Addendum No. 01

DSA Appl. No. 01-122194

Project: Hayes Elementary School Repaving
2035 Poston Drive
San Jose, CA 95136
Oak Grove School District

Project No: 24012

Hayes Site Map – Coring results.

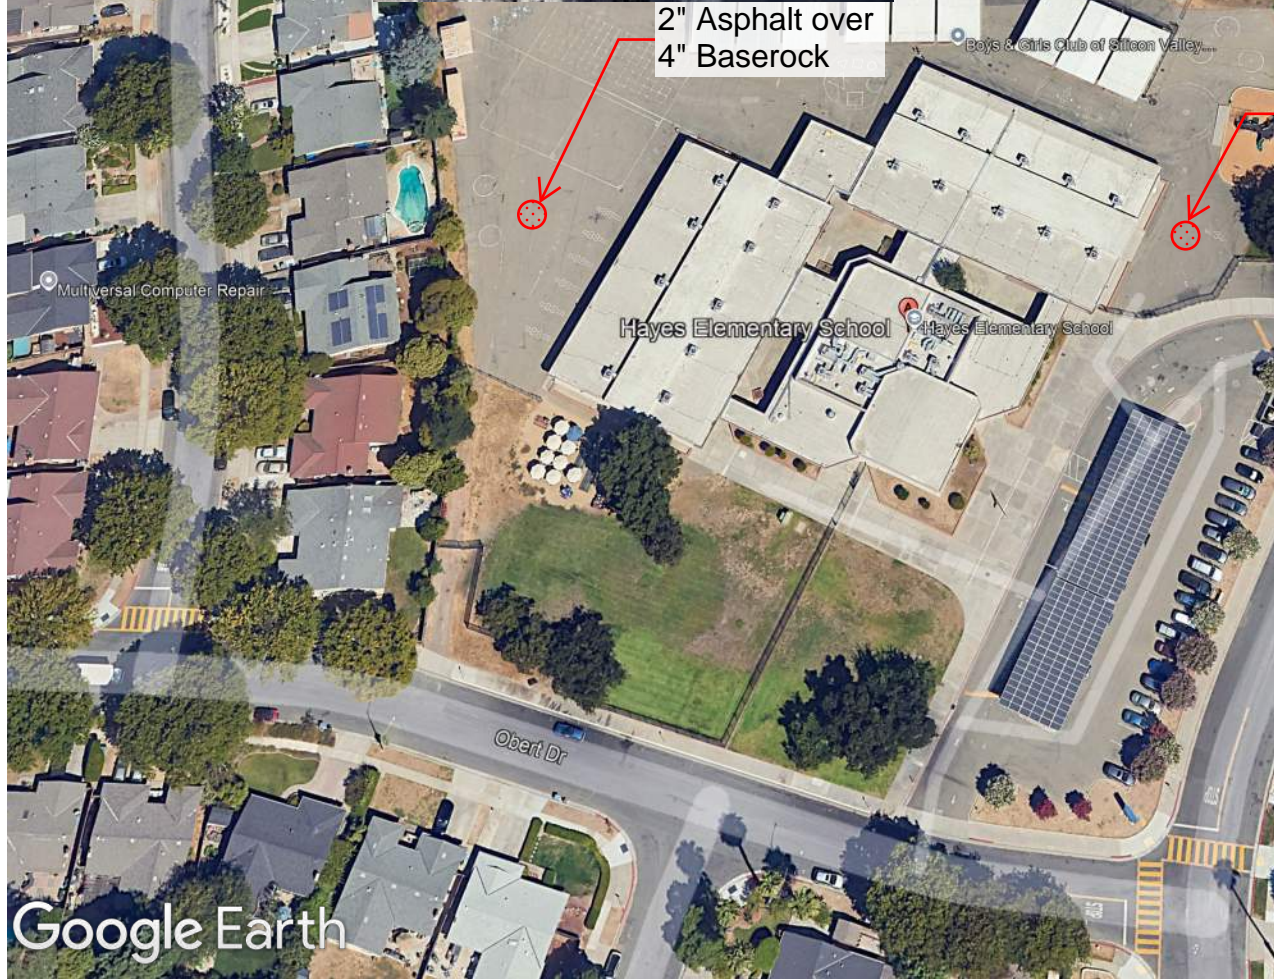
C6: Does the District have a geotechnical report for this site?

A6: No. Please see the attached coring's to show existing thickness.

2" Asphalt over
4" Baserock

2" Asphalt over
2" Baserock
